**RE:** **P.Z. 30-2007 Spirit Energy, LLC (13506 Olive):** A request for a change of zoning from a "C2" Commercial District with a Conditional Use Permit to a "PC" Planned Commercial District for a .31 acre tract of land located at 13506 Olive Blvd at the southwest corner of Olive Blvd and Woods Mill Road.

## Planning Commission Staff Report

**Petition:** P.Z. 30-2007 Spirit Energy, LLC (13506 Olive)

**PRELIMINARY DEVELOPMENT PLAN**

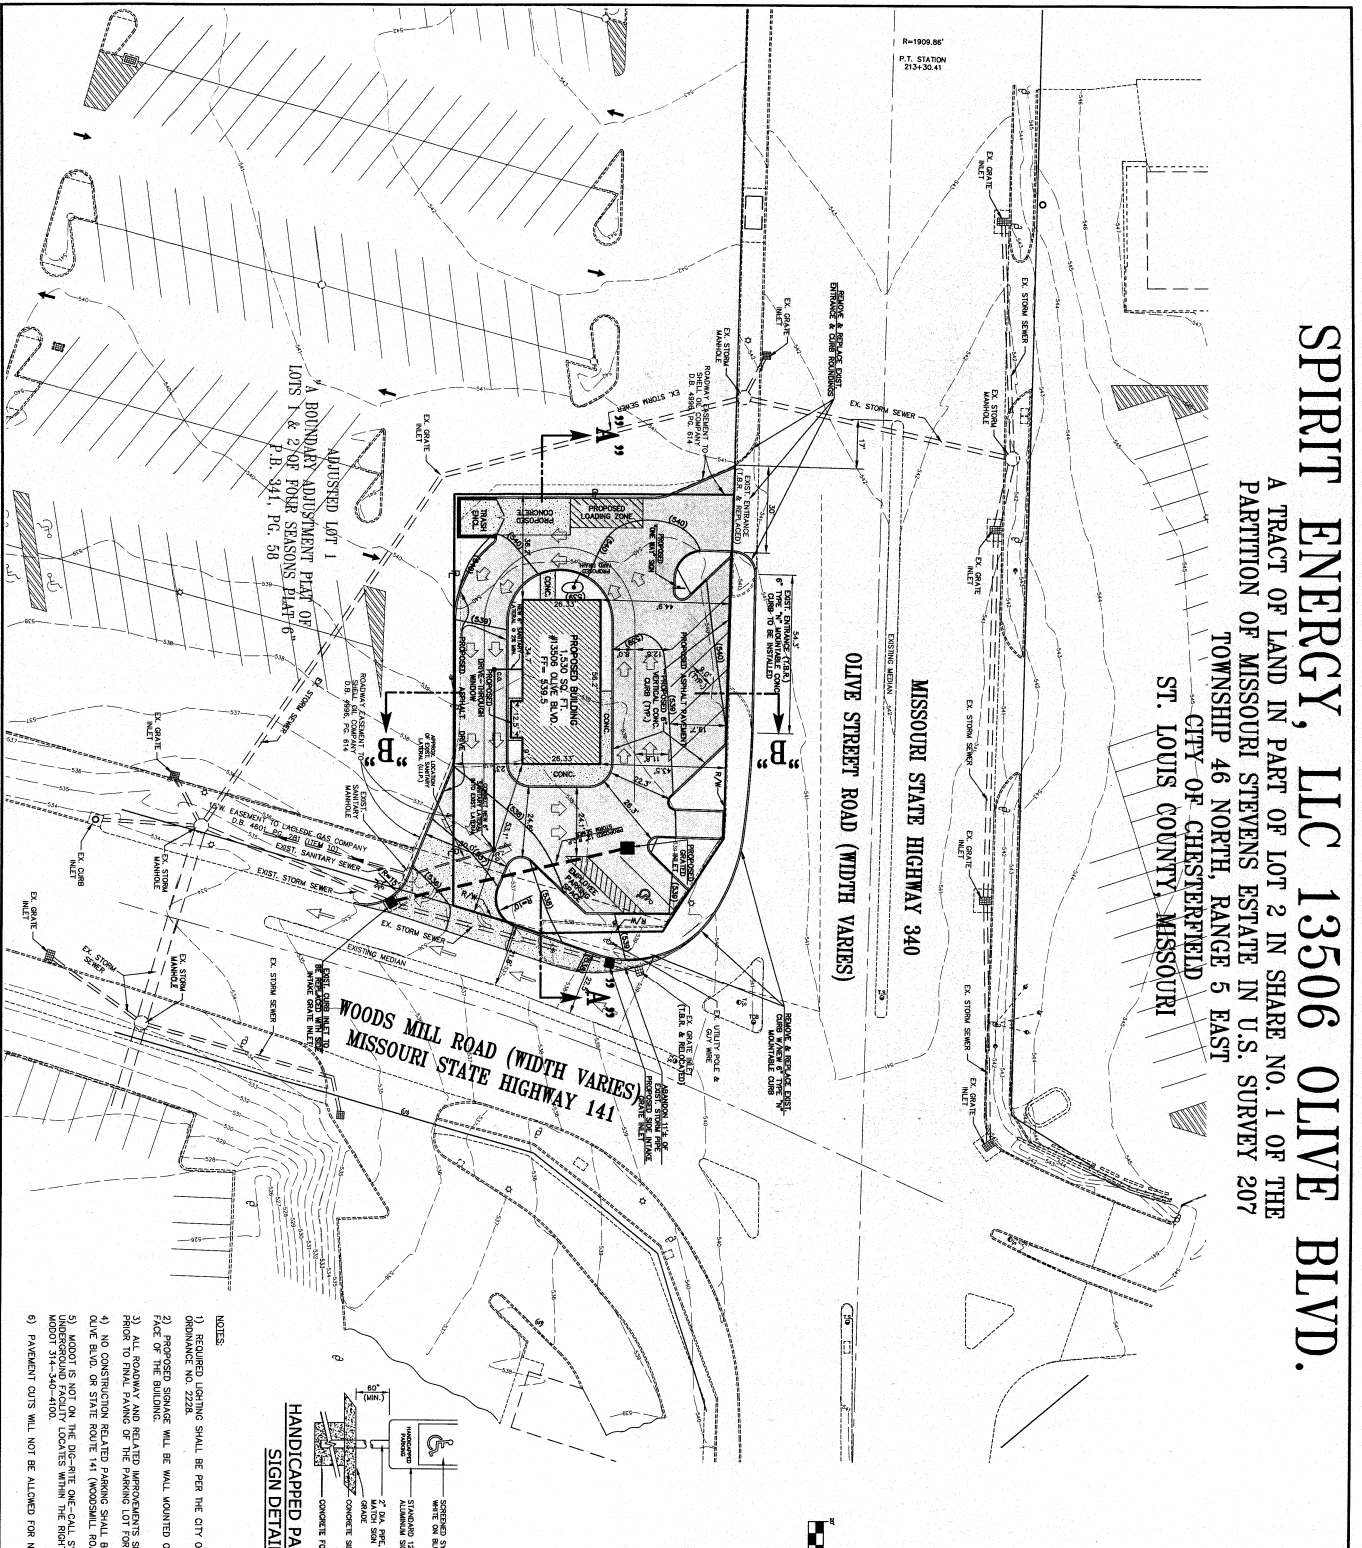
The preliminary plan submitted with this rezoning request currently does not adhere to the City's Access Management Ordinance. Specifically, the length of the driveway throat for the entrance onto Woodsmill Road is too short. The Access Management Ordinance requires a minimum of 45 feet as measured from the edge of the street to the nearest edge of the first drive. The preliminary plan depicts a distance of only 22 feet.

12. The preliminary plan still depicts a potential traffic conflict at the entrance onto Route 141. In addition, the pavement widening actually reduces the driveway throat length and brings the traffic conflict closer to the roadway pavement than previously submitted plans. This is being worked on with the advice of MoDot.

14. The Preliminary Plan indicates that the vehicles that will be using the drive thru lane will not be able to stay within the limits of the drive thru lane. Even a passenger car will encroach on the adjacent travel lane which will likely impede traffic flow within the site and increase the possibility of traffic conflicts on the adjacent roadways. The drive thru lane will be adequately wide enough to allow a vehicle to stay within its limits.

15. A single unit truck can not traverse through this site. In addition, if a single unit truck, such as a trash truck comes onto the site from Olive Boulevard and then exits via State Route 141, the truck will not be able to exit without driving over the curb. In addition, the single unit truck can not enter the site from State Route 141 and successfully negotiate the necessary turns to reach the trash enclosure or the loading space provided on the western parcel line. A trash truck will be able to exit onto hwy 141 in the same manner it does from adjoining properties. They will enter the lot from Olive Blvd.

16. The plan indicates that the curb along Olive Boulevard will be replaced with a mountable curb directly adjacent to the proposed five (5) foot wide sidewalk. The curbing in this area will need to provide a barrier between pedestrian and vehicular traffic. We will discuss this with the City of Chesterfield and MoDot to resolve the issue. We are under the impression that MoDot would prefer not to have a sidewalk, as there are no sidewalk's currently at this intersection.

17. Please be advised that the proposed no entrance sign located near the entrance at Olive Boulevard will need to be relocated such that it properly directs and informs drivers of on site traffic flow direction. The plan appears to inform drivers that they can not enter the site from Olive Boulevard. The sign can be relocated.
